The Boston Garden

BOSTON PROPERTIES AND DELAWARE NORTH COMPANIES

DESIGN DEVELOPMENT SUBMISSION TO **BOSTON REDEVELOPMENT AUTHORITY**

FEEDBACK FROM PREVIOUS BCDC PRESENTATION

MEZZANINE CONFIGURATION: NEW BASE OPTION

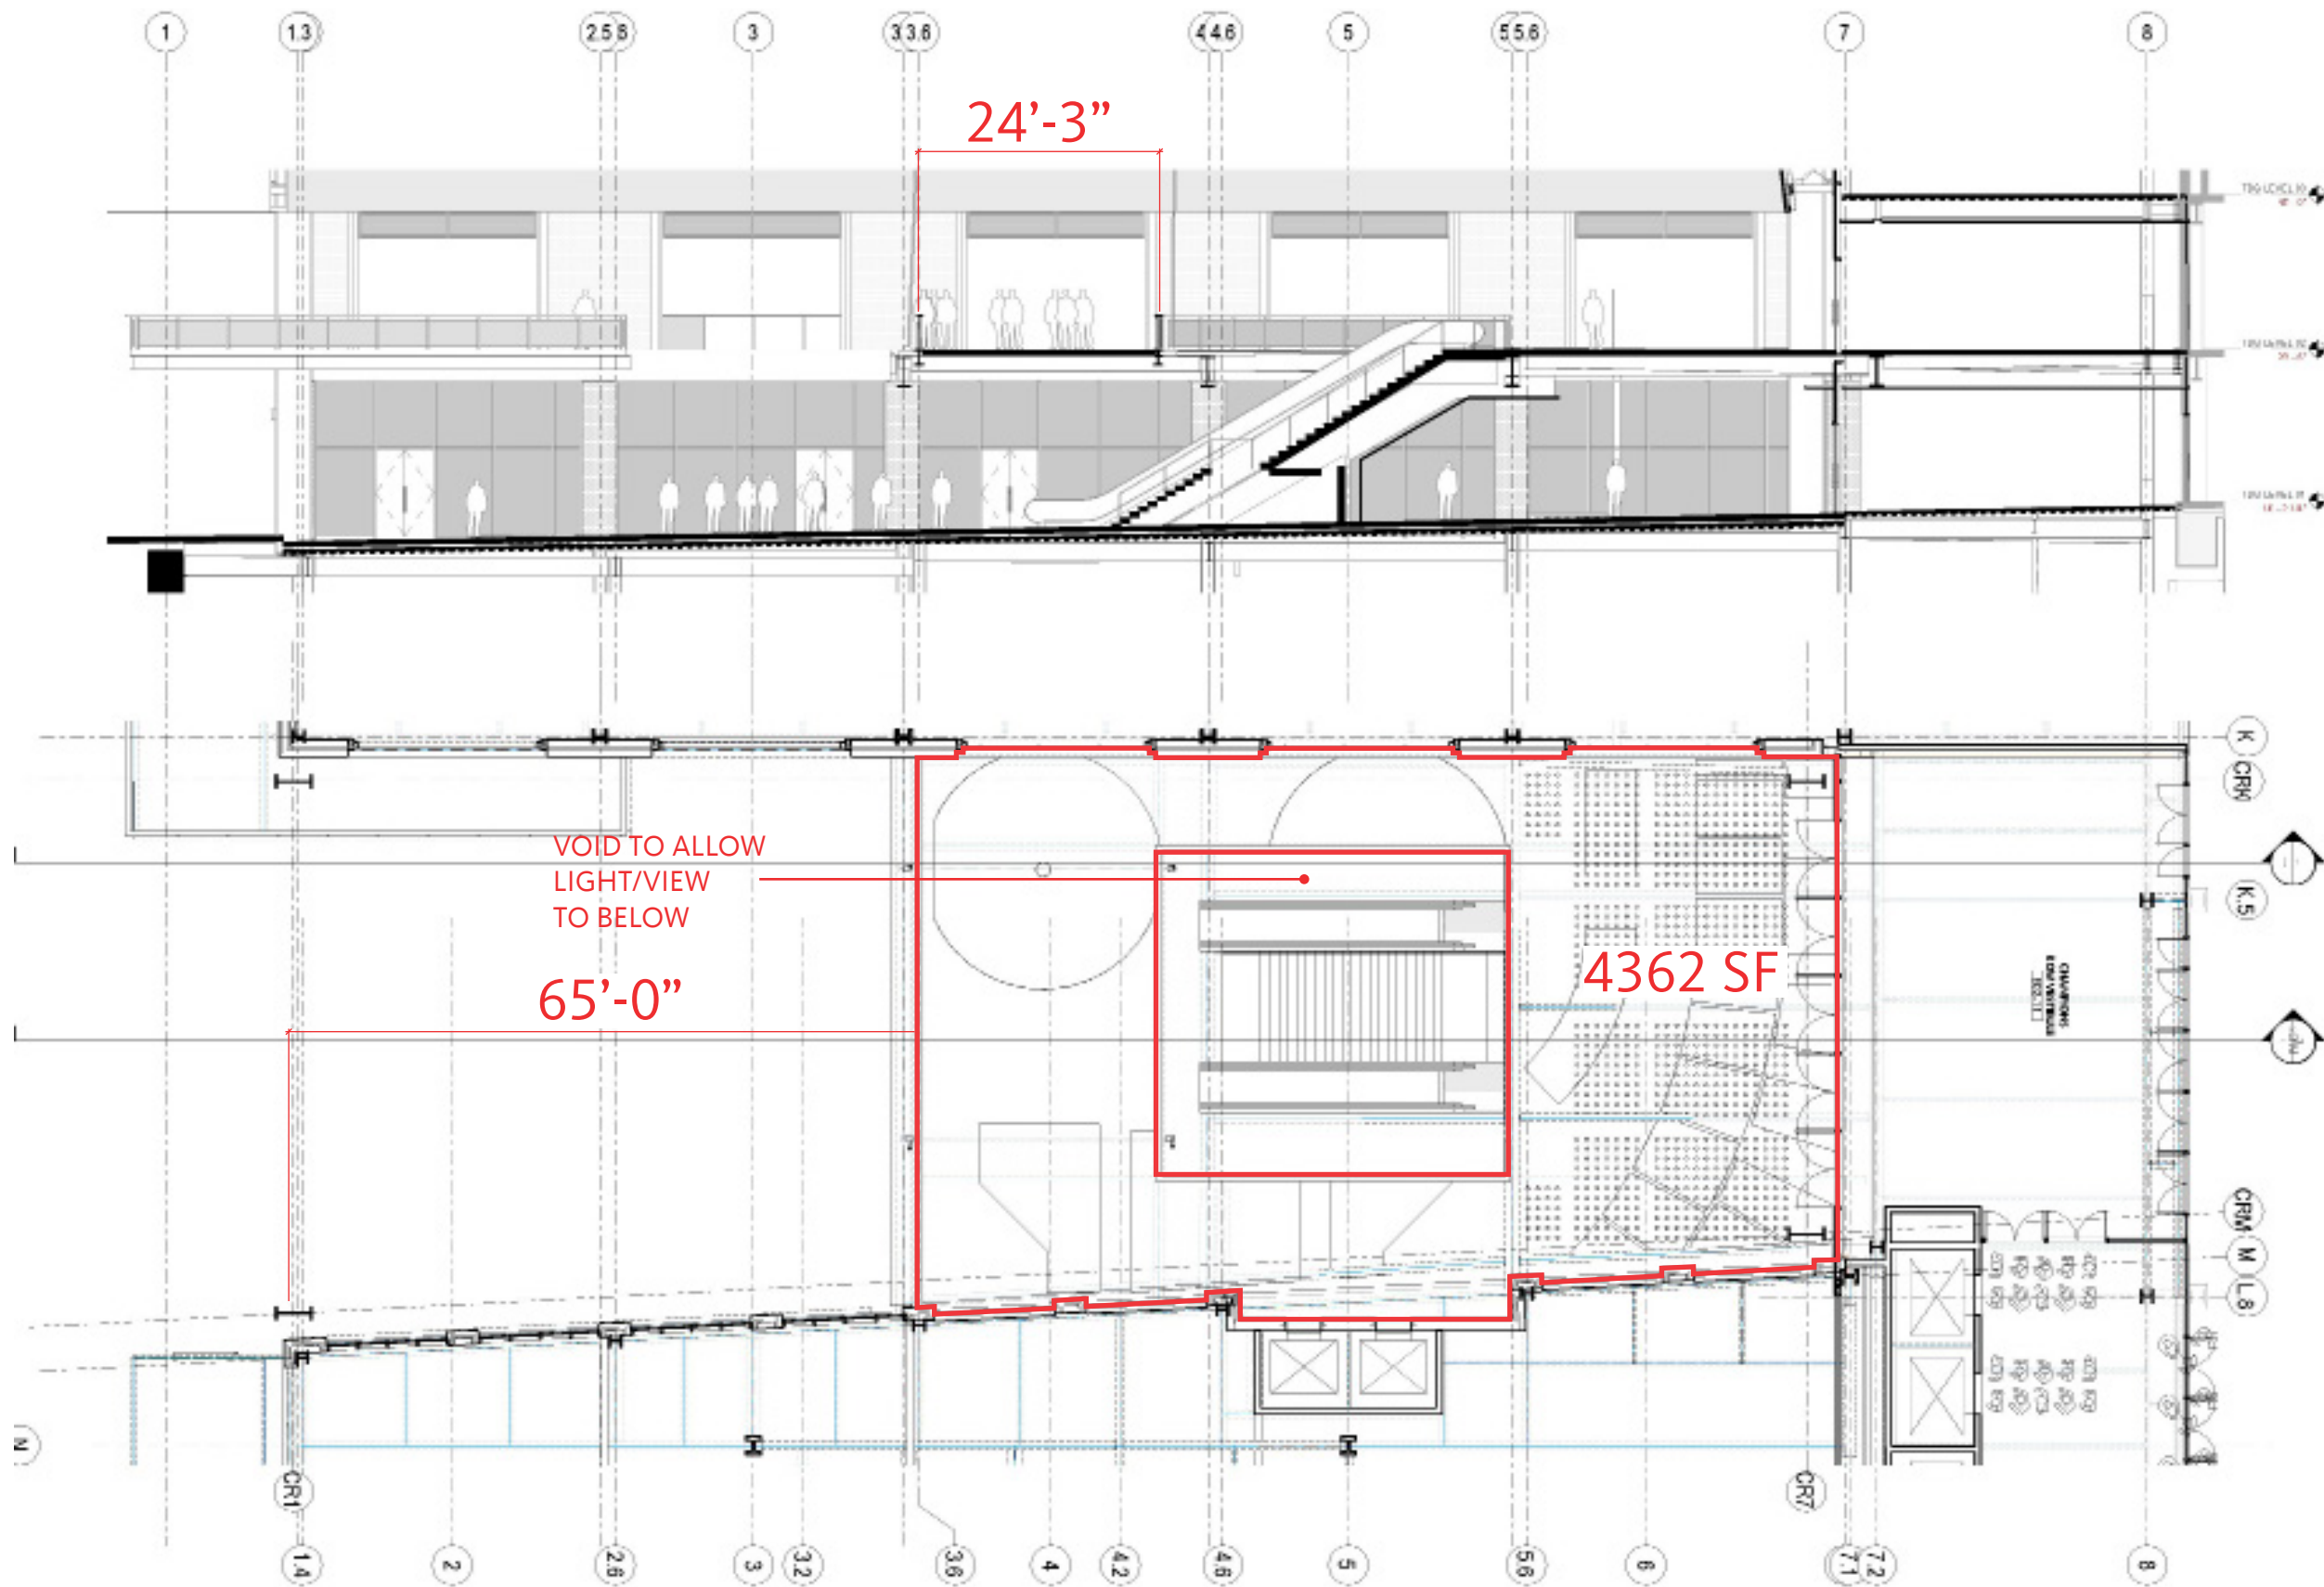
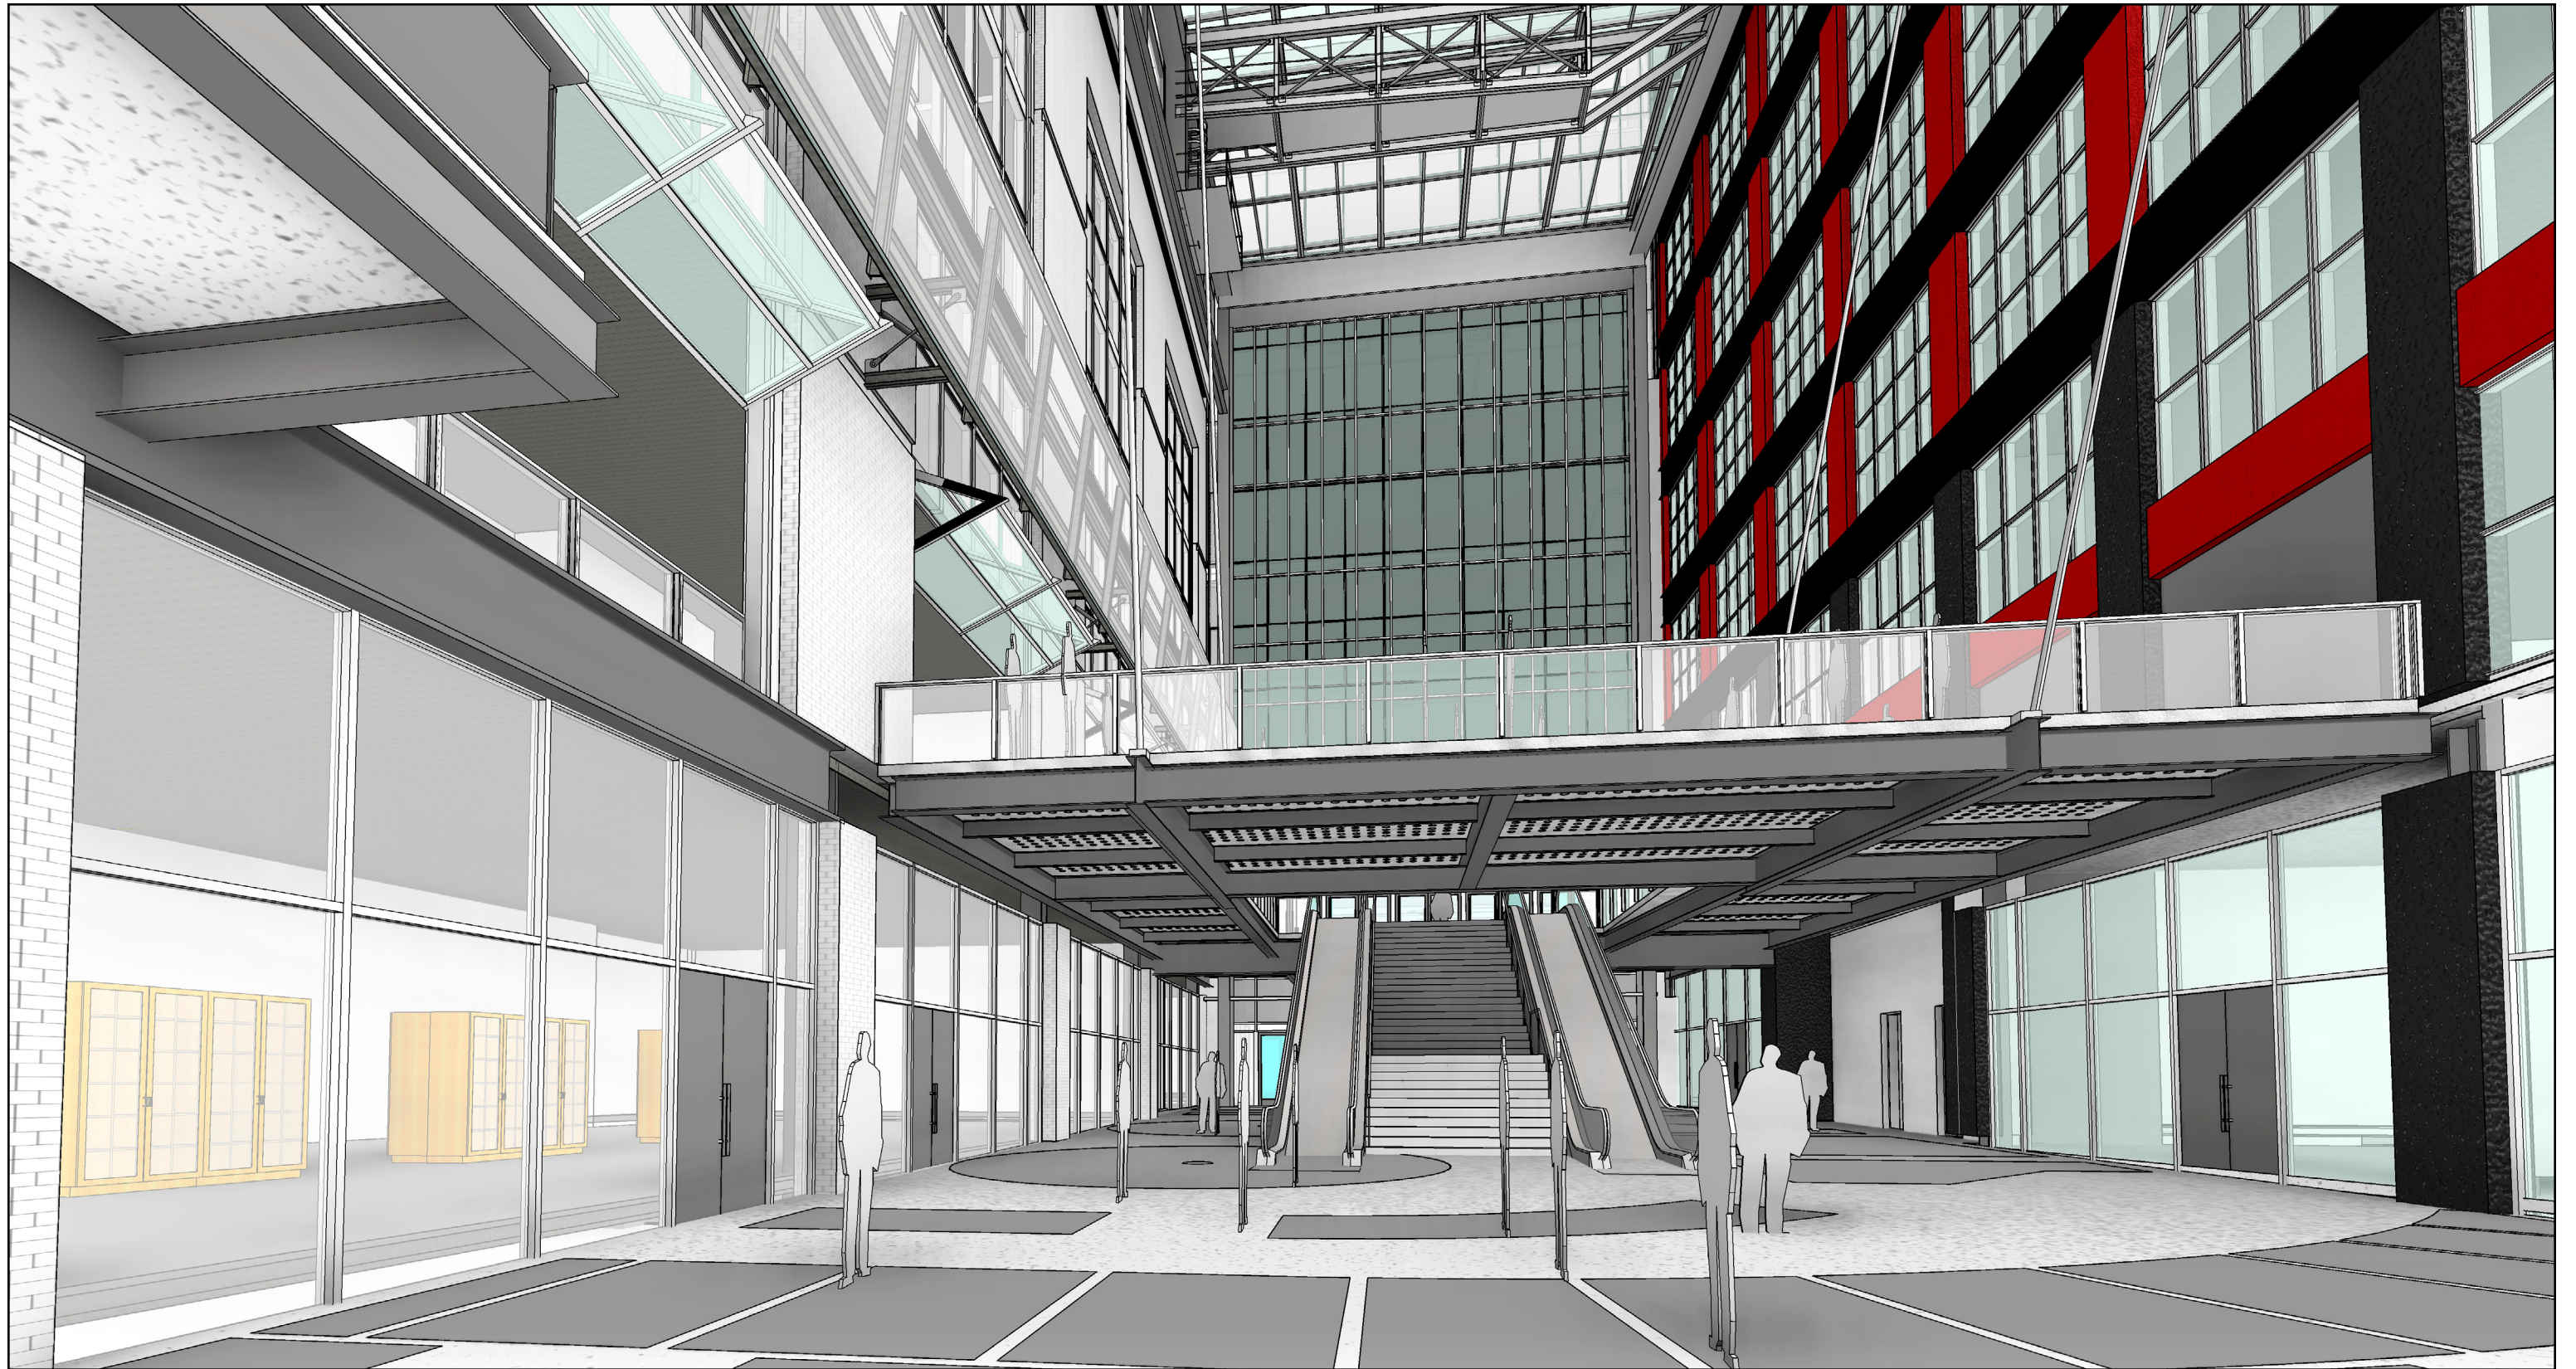
SATISFIES DRIVERS?

1. PEDESTRIAN FLOW
YES

2. A PLACE ABOVE
YES

3. VISIBILITY AND ACCESS TO RETAIL TENANTS
YES
